DA Number	DA 2026 / 00047
Applicant	A Beswick
Proposal	Residential - Additions and Alteration to Existing Dwelling and Extension to Existing Outbuilding
Location	104 Main Road, Binalong Bay (CT 240588/5)

Subject: Response to Request for additional information – DA2026/00047

Project: Additions and Alteration to Existing Dwelling and Extension to Existing Outbuilding.

Site: 104 Main Road, Binalong Bay TAS 7216

Drawing No:
EP2025-89 A101 / A11

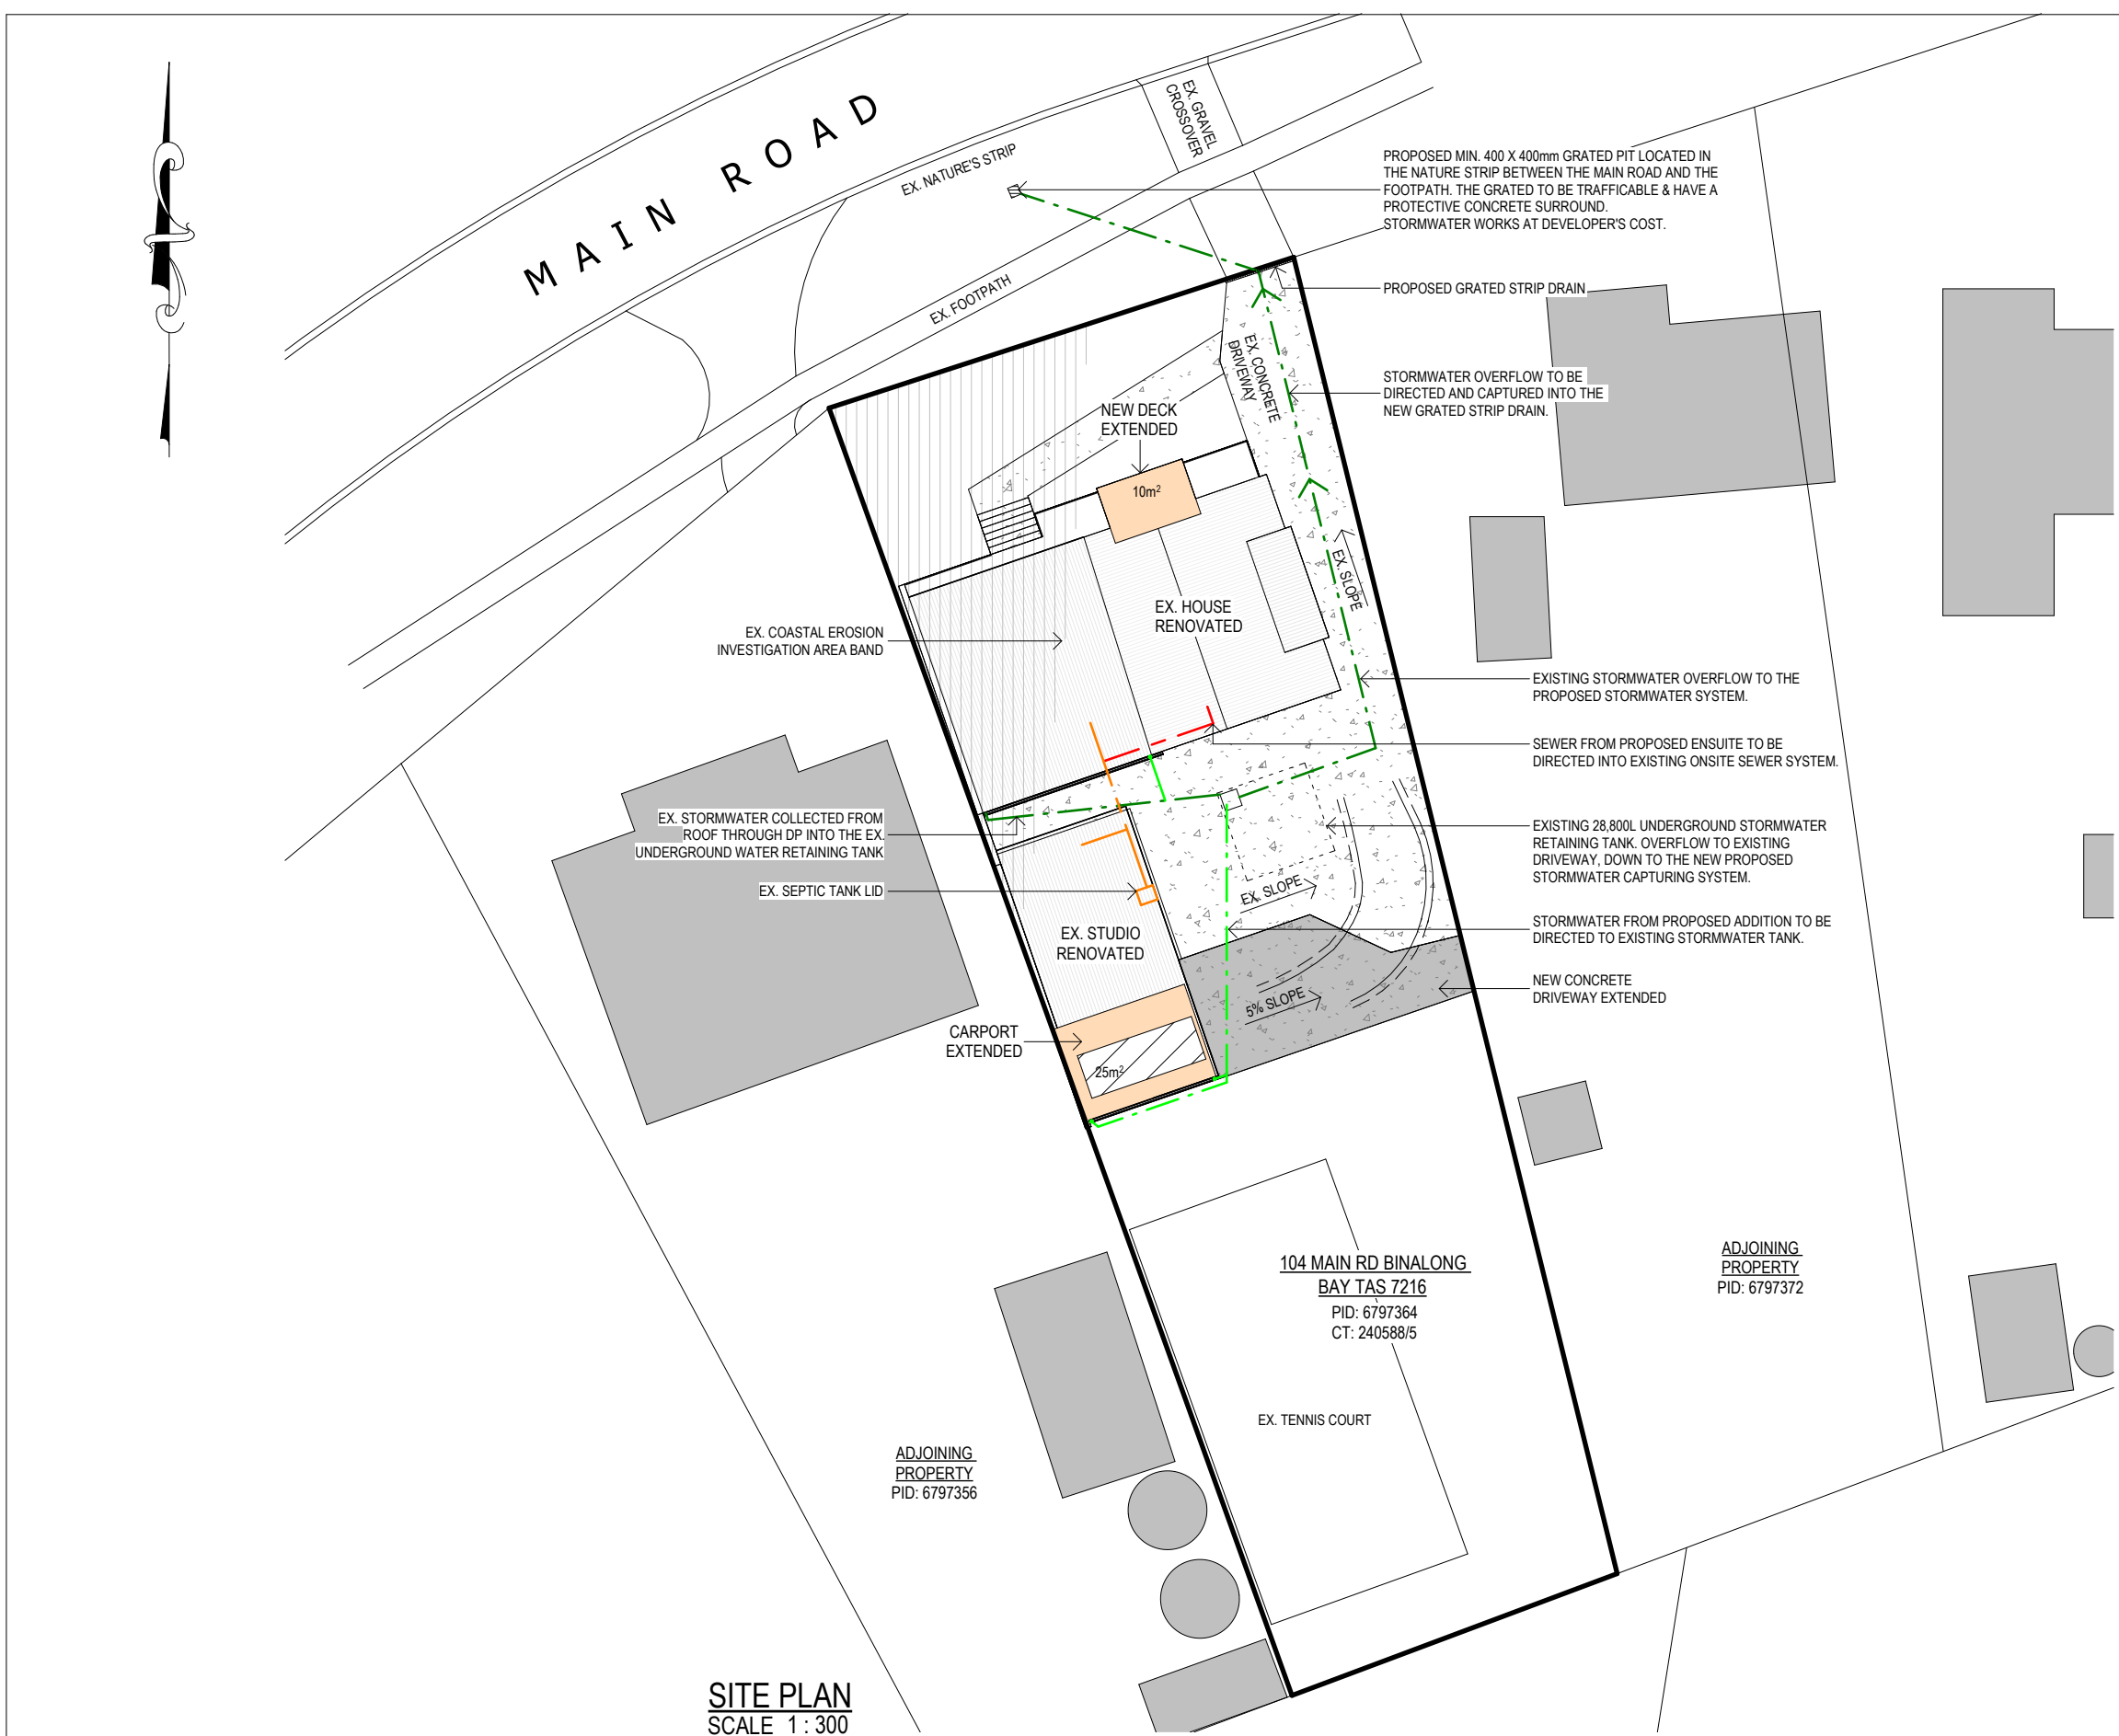
- **Driveway material**

- **Stormwater management**

The proposed extension to the existing driveway will be constructed of concrete, as indicated on Site Plan Drawing No. A02.

Stormwater from the proposed additions and alterations will be directed to the existing stormwater connection. Roof water from the proposed extension will be collected via new downpipes and discharged into the existing underground rainwater tank.
